ZONING CONDITIONS FOR THE MERRITT RESERVE

CONSTRUCTION DRAWINGS FOR MERRITT RESERVE

PROJECT NUMBER = CID-25-XX

JOB NUMBER: 23-0004
 CHECKED BY: BH
 DRAWN BY: DH/RC/SM/GE/MA/LL/JB
 DATE: 04/14/2025
 SHEET TITLE:
CU-202 PLAN & PROFILE
 SHEET NO.: ---

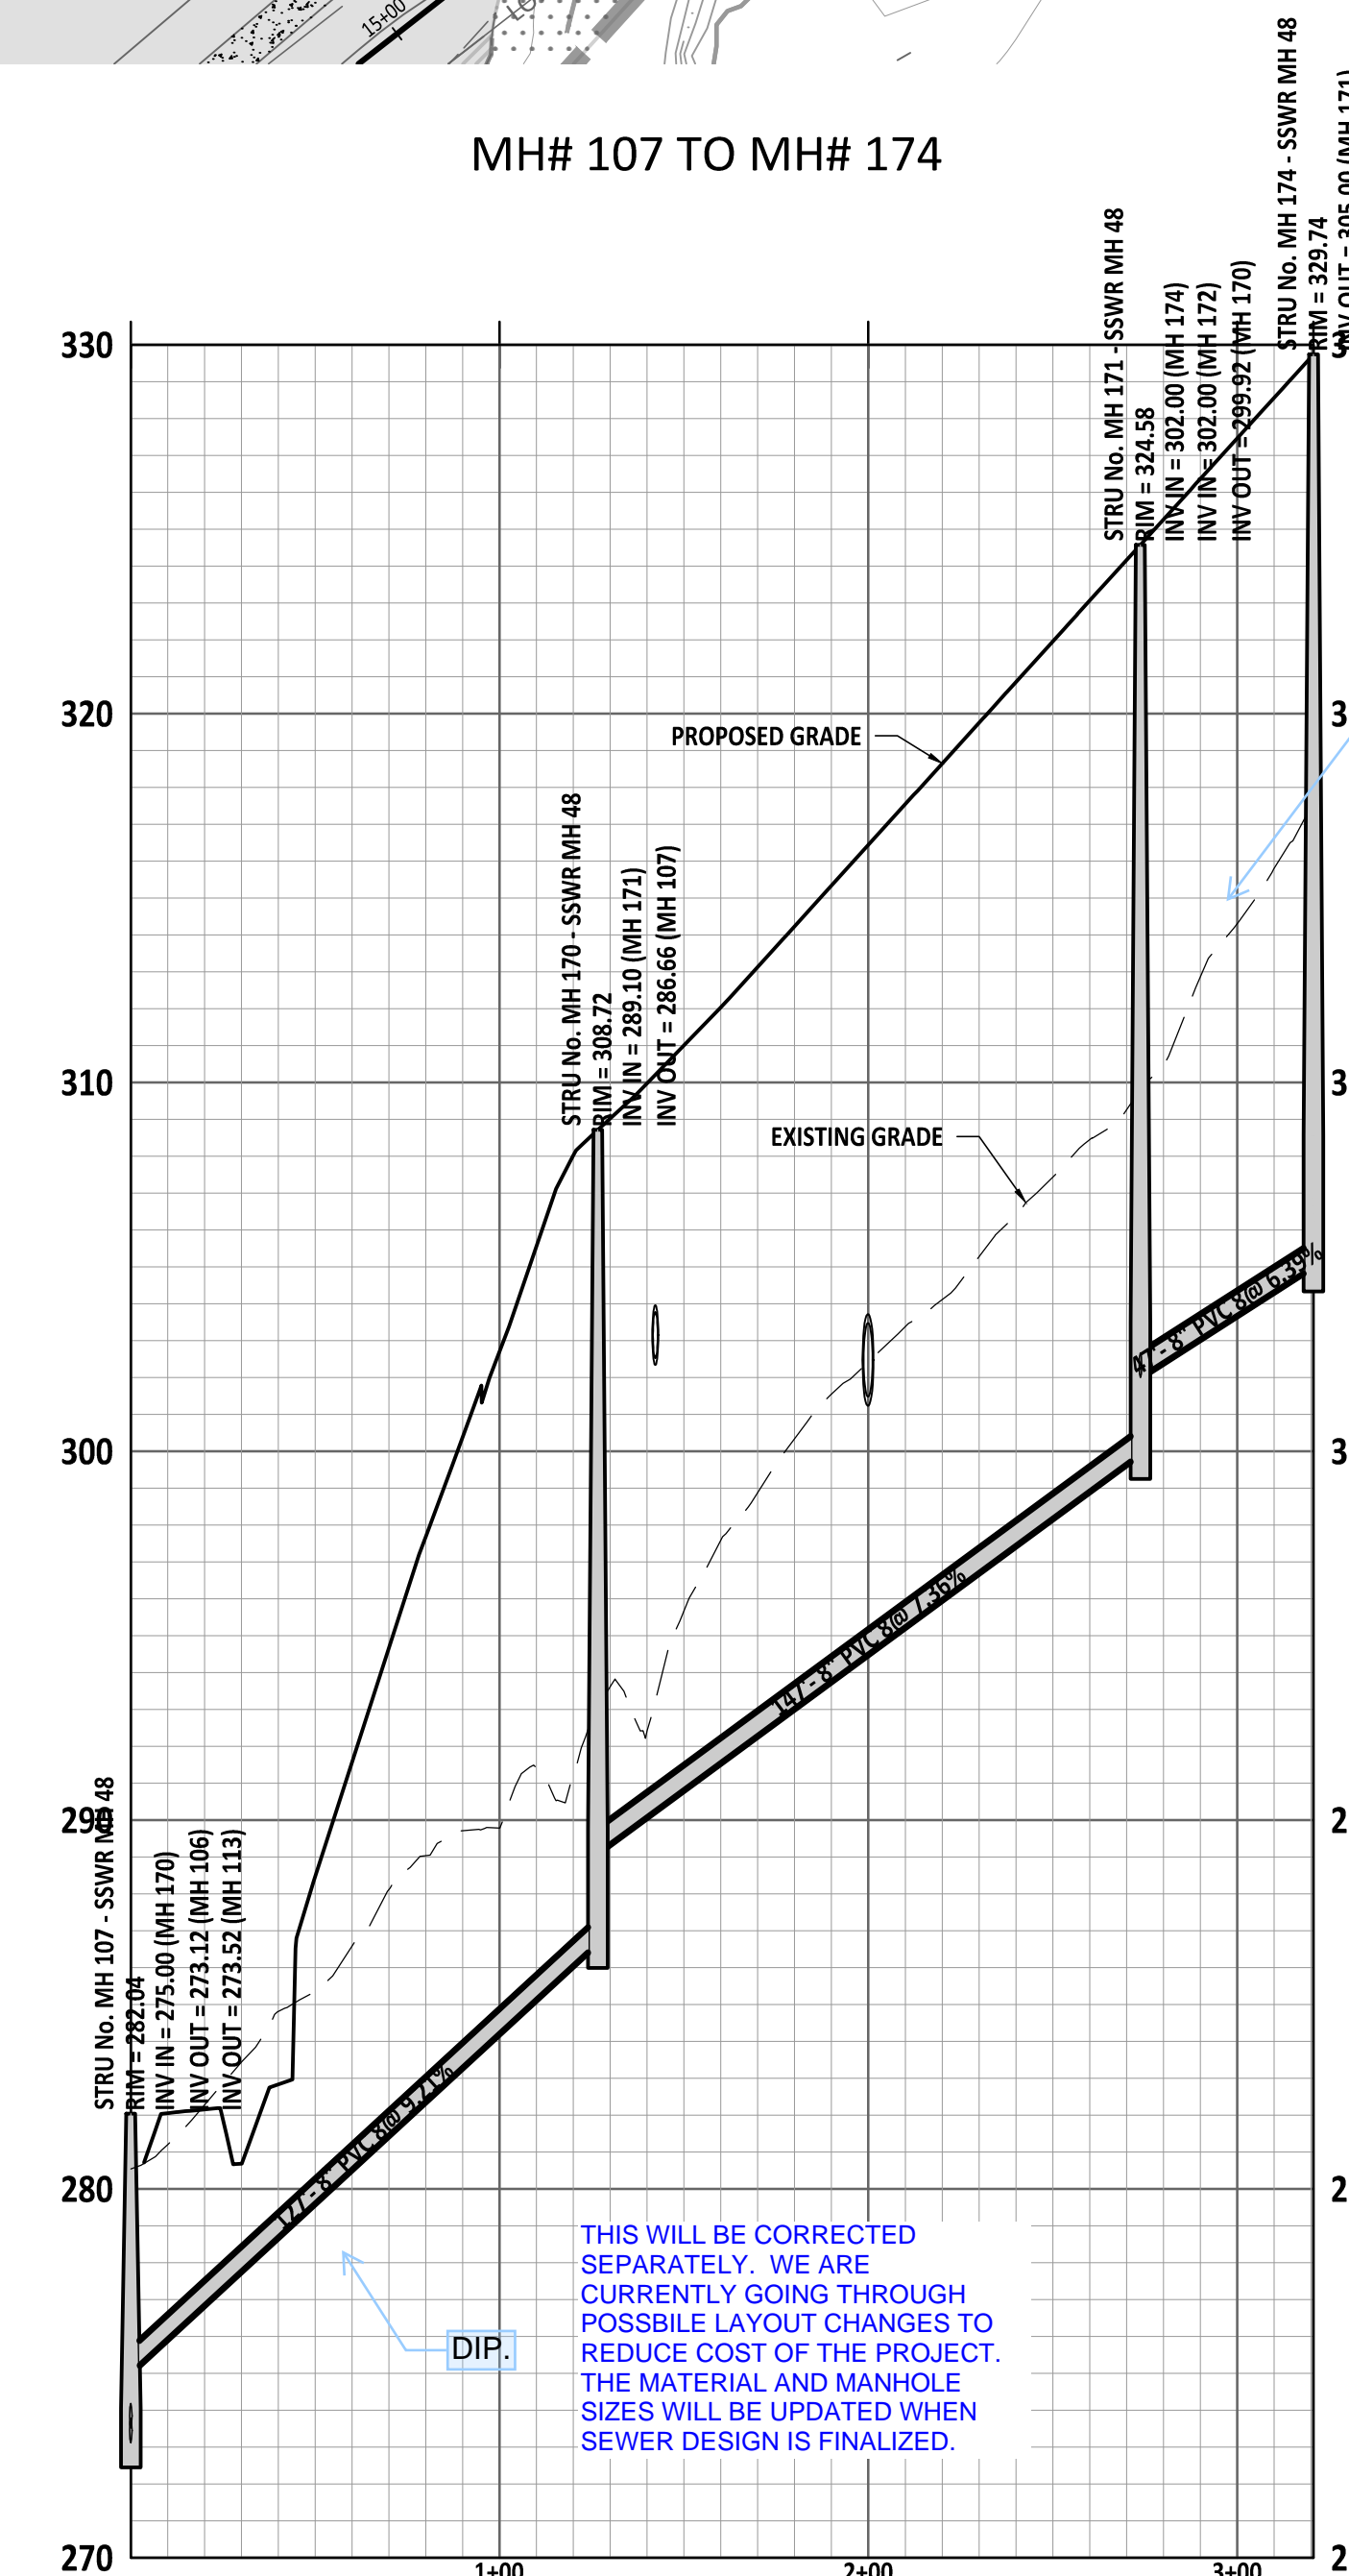
SDR 26 PVC if installation depth exceeds 12'.

Please provide 2/10 drop between inverts. THIS HAS BEEN CORRECTED

This sewer is uncomfortably deep for installation within a roadway...this will be greatly problematic for future maintenance. You'll need to demonstrate that no other design alternatives for sewer installation are feasible for Raleigh to allow this...

THIS WILL BE CORRECTED SEPARATELY. WE ARE CURRENTLY GOING THROUGH POSSIBLE LAYOUT CHANGES TO REDUCE COST OF THE PROJECT. THE MATERIAL AND MANHOLE SIZES WILL BE UPDATED WHEN SEWER DESIGN IS FINALIZED.

THIS WILL BE CORRECTED SEPARATELY. WE ARE CURRENTLY GOING THROUGH POSSIBLE LAYOUT CHANGES TO REDUCE COST OF THE PROJECT. THE MATERIAL AND MANHOLE SIZES WILL BE UPDATED WHEN SEWER DESIGN IS FINALIZED.

THIS WILL BE CORRECTED SEPARATELY. WE ARE CURRENTLY GOING THROUGH POSSIBLE LAYOUT CHANGES TO REDUCE COST OF THE PROJECT. THE MATERIAL AND MANHOLE SIZES WILL BE UPDATED WHEN SEWER DESIGN IS FINALIZED.
